S **p** **e** **c** **i** **a** **l** **i** **s** **t** **E** **n** **v** **i** **r** **o** **n** **m** **e** **n** **t** **a** **l** **S** **e** **r** **v** **i** **c** **e** **s** **L** **t** **d**

8th August 2024

**Memorandum: Technical Review of the Assessment of Effects of
Discharges to Air: Waste Management Fairfield Closed
Landfill**

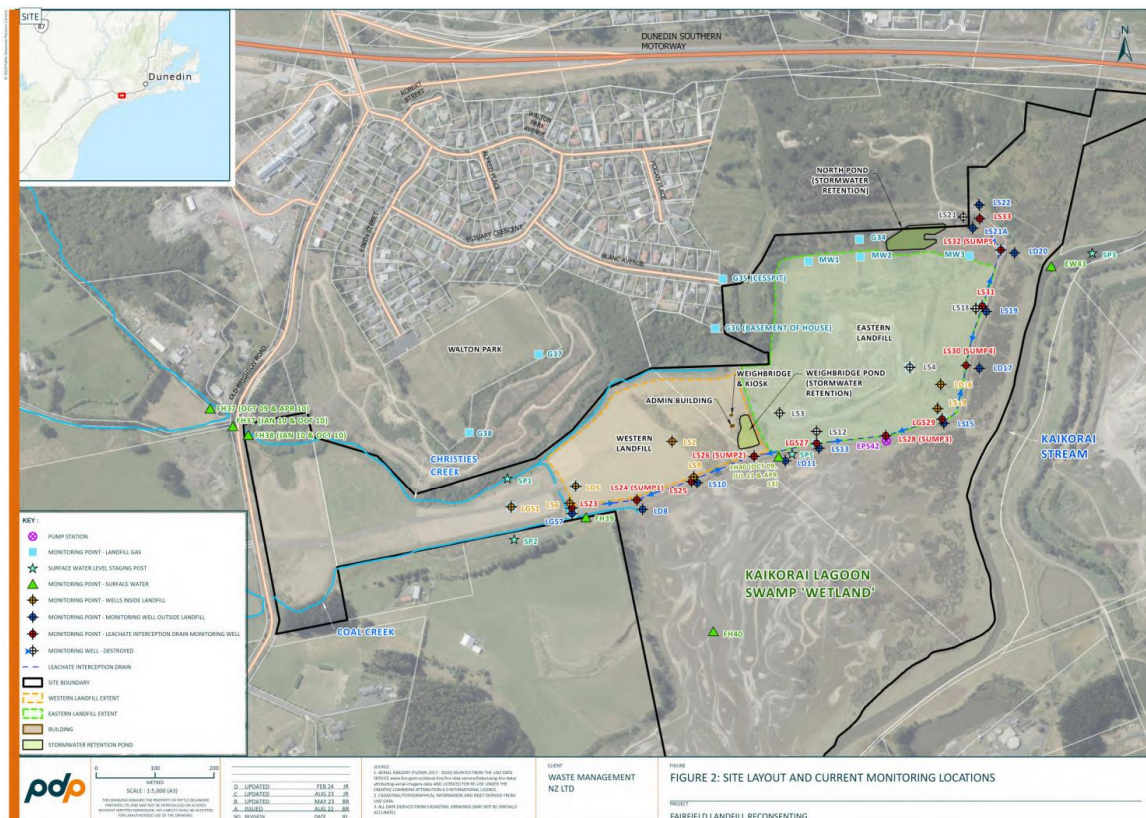
The T&T report relies on the analysis of LFG migration in the Pattle Delamore Partners (PDP) report attached as Appendix 5 of the AEE. The PDP report concludes that “the risk to nearby residents from subsurface LFG migration from the landfill areas is acceptably low”. It is unclear if this conclusion also applies to future residents on the residentially zoned land to the north of the site.

PDP have analysed the existing quarterly LFG monitoring data gathered from numerous locations within and around the landfills. As expected, the monitoring indicates that only minor LFG emissions are being generated from the Western Landfill that has been closed for 27 years. With regard to existing dwellings, LFG monitoring has occurred in a cesspit at the end of Blanc Avenue and in the basement of the house at 34 Blanc Avenue. This monitoring did not indicate the presence of significant LFG concentrations.

Limited monitoring has occurred to assess potential lateral migration from the Eastern Landfill to the north, towards the residential zoned land most at risk. Wells MW1-3 are within the northern edge of the landfill so do not provide relevant data for this purpose. Sentinel well G34 is located further north, beyond the landfill, and provides relevant information. PDP note that monitoring at this well since 2006 shows no obvious signs of

subsurface migration (maximum 0.3% CH₄). I note that one measurement at this well in January 2019 recorded 4ppm H₂S and 180ppm CO, but the corresponding CH₄ result was small. Similar, slightly elevated H₂S and CO readings were taken at G36 (cesspit) and G36 (basement) on the same date.

Bearing in mind the limited information to date and the likely future development of the residential zone to the north, I consider that it would be appropriate to include two additional LFG monitoring wells (sometimes referred to as probes) screened to at least 3m deep along the northern site boundary of the Eastern Landfill. Suggested locations are at the site boundary to the north of MW1 and MW3 shown on the plan below, taken from the PDP report. Monitoring of these wells would allow further confirmation that the risk of subsurface migration is low, prior to residential development occurring.
